CITY OF PORTLAND, MAINE

Project Name:	Bayside Bowl	Project ID:	#2015-230
Address:	71 Hanover Street	CBL:	34-H-5
Applicant:	BOPO, LLC		
Planner:	Richard Knowland

Rick Knowland - Bayside Bowl - Final Traffic Comments

Bayside Bowl Expansion
138 Kennebec Street
Level III Site Plan
Project ID #2015-230
BOPPO, LLC., Applicant.

Proposed 2016 Site Plan

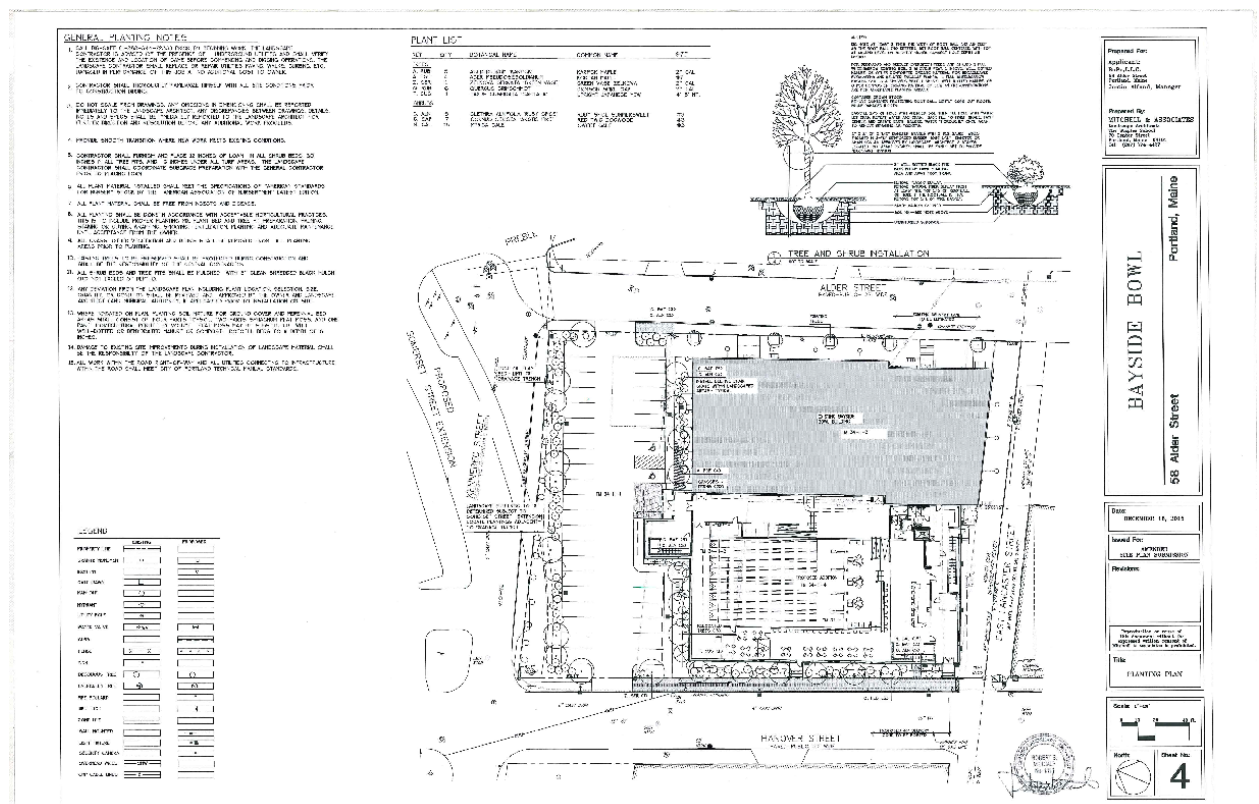
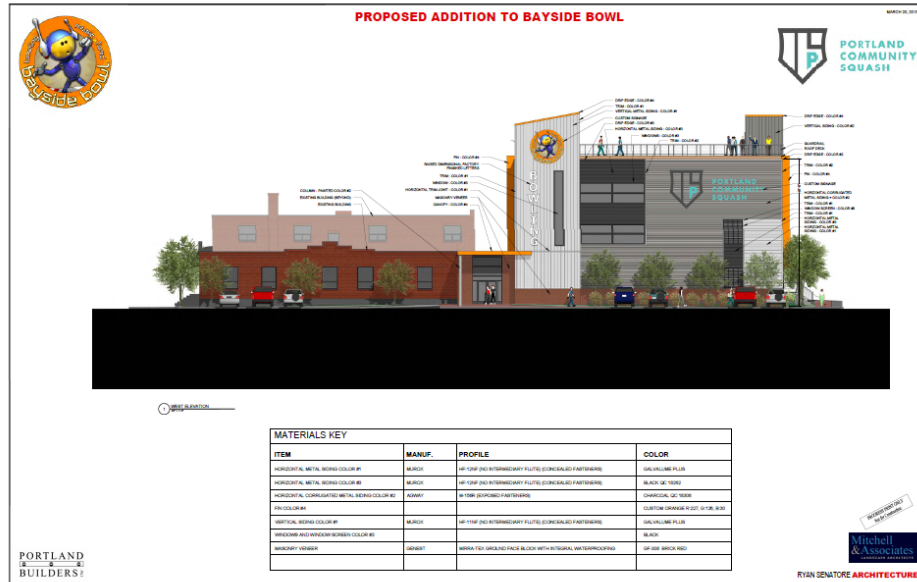
Parking includes a permanent 36 space lot on-site, as well as references to a number of off-site parking spaces although no agreement(s) documenting permission from applicable property owners has been provided. The 36 space parking lot was originally approved by the Board in 2015 as a gravel temporary parking lot pending enactment of a B-7 zoning amendment which allowed flexible parking lot setbacks. The amendment was approved by the City Council enabling Bayside Bowl (like the recently approved Schlotterbeck Foss site plan) to pursue a parking lot closer to the street line than otherwise permitted.

An 8 foot wide brick sidewalk is proposed along Hanover Street, while the existing brick sidewalk along Alder Street is being extended about 22 feet. Both sidewalks stop at the parking lot driveway in deference to the future alignment of Somerset Street, which will likely be constructed within the next two years. The proposed alignment is shown on the plan below. Three Bayside street light fixtures are proposed along Hanover Street.

Proposed 2016 Kennebec St. Elevation

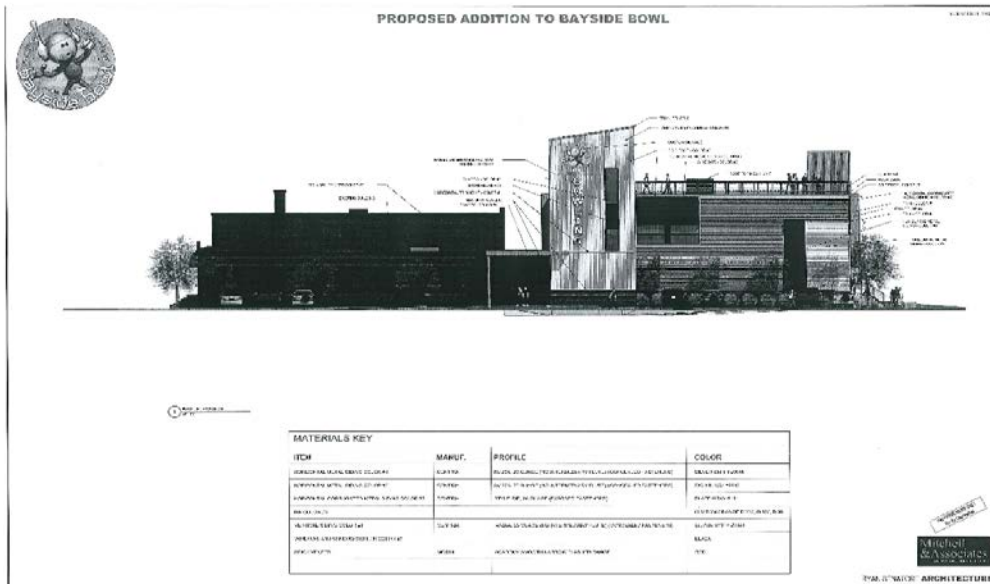
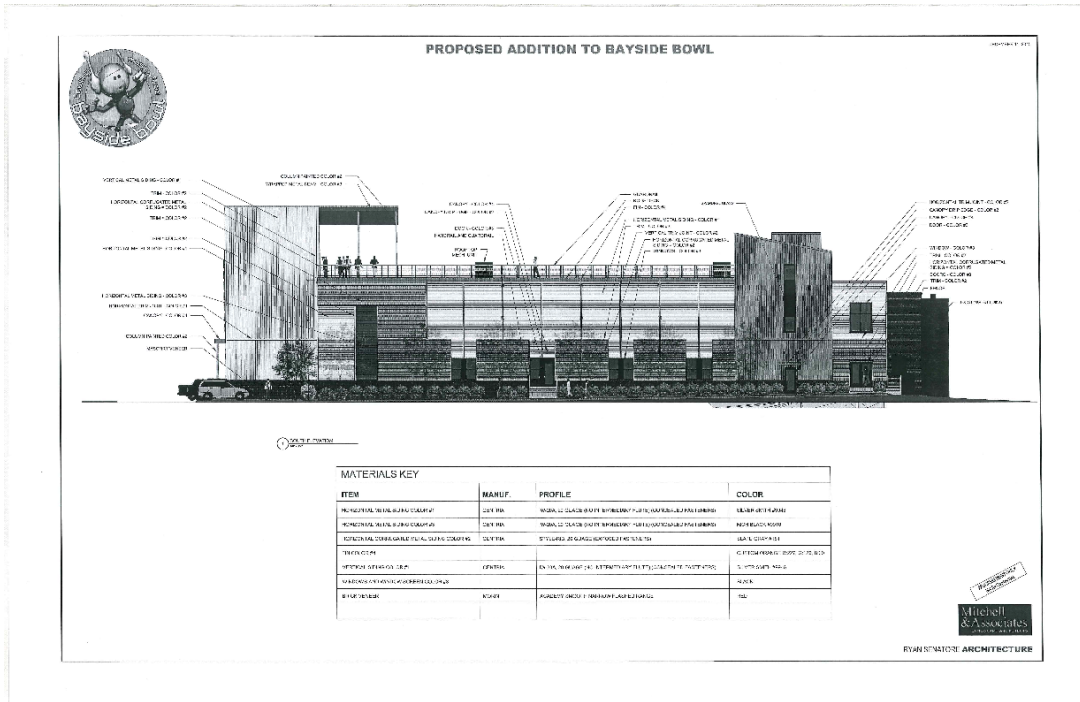
The original building elevations were approved without conditions. The updated building elevations look virtually identical to the original elevations except the building is about 11 feet shorter. See Attachment Plans. Exterior building treatment and materials appear consistent with the previous submission. Kennebec Street and Hanover Street views are shown below. The proposed addition makes a major statement in overall building mass on the site. While the building has only one full floor plus a mezzanine level, it reads as a taller building with its 34 foot height. The building is surrounded by 4 streets so the building is viewed by the public from all 4 streets.
